# ULPOWER AERO ENGINES N.V.

## SERVICE INSTRUCTION

Service Instruction No. 2020-02-RECTIFIED

### Inspection of Hall Sensors for possible oil weep.

Figure 1 : IPC UL260i detail page 24

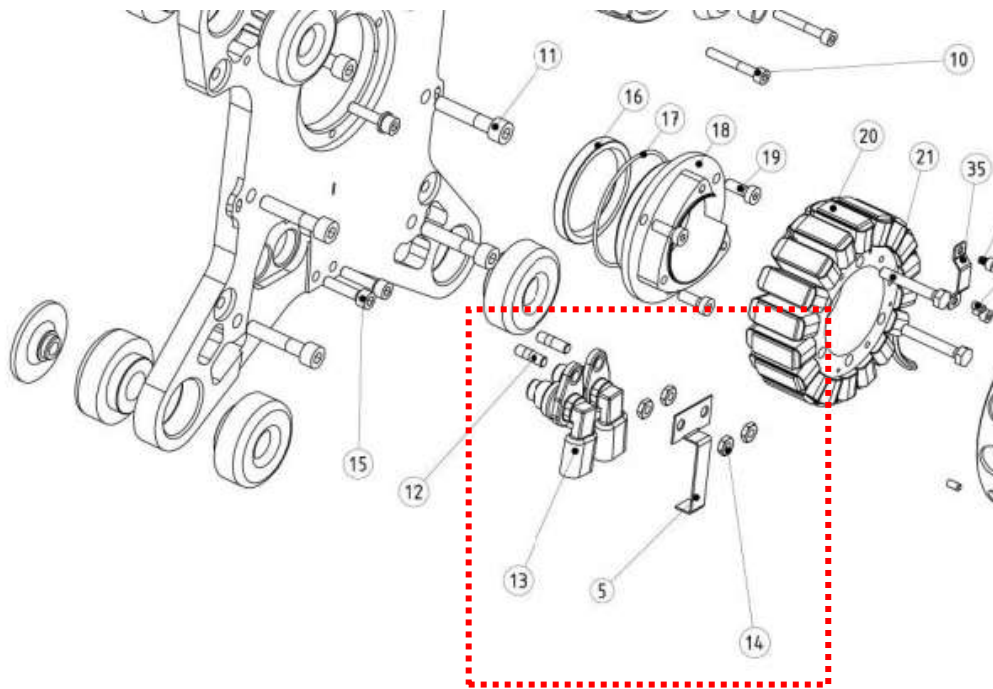
Parts needed : S1018116 O-ring Viton 18.1x1.6 (2 for single ECUs and 4 for dual ECU)

Illustrated Parts Catalogue references :

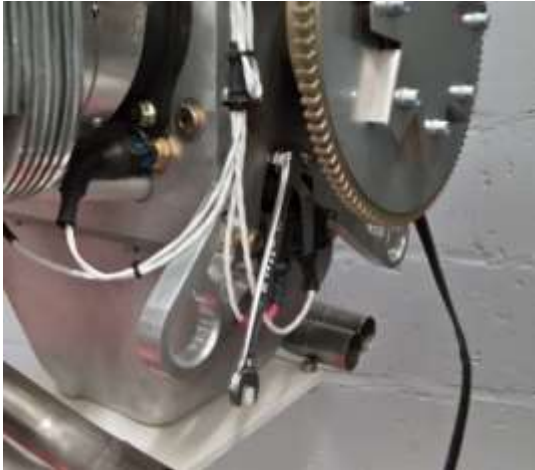
- 1) Unscrew the 2 hexagon M6 nuts (IPC item 14) and remove the locking plate hall sensor (IPC item 5)

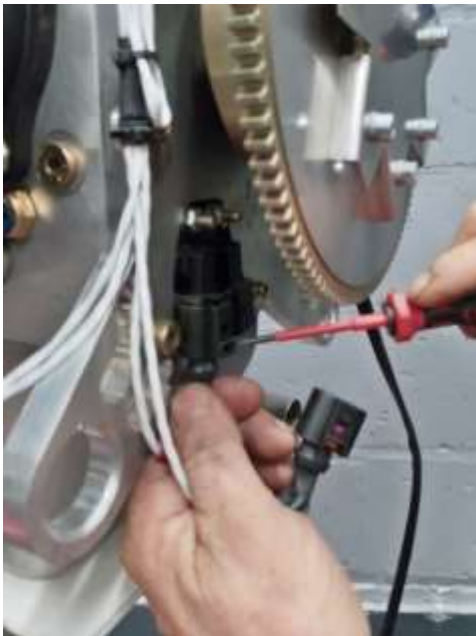
- 2) Disconnect the 2 hall sensor connectors.  
To do so, push the connector up, then push down the clips (use flat head screw driver).  
You are now able to remove the connector

- 3) Unscrew the 2 hexagon M6 nuts (IPC item 14) which hold the hall sensors.  
Gently pull the sensor out of the backplate
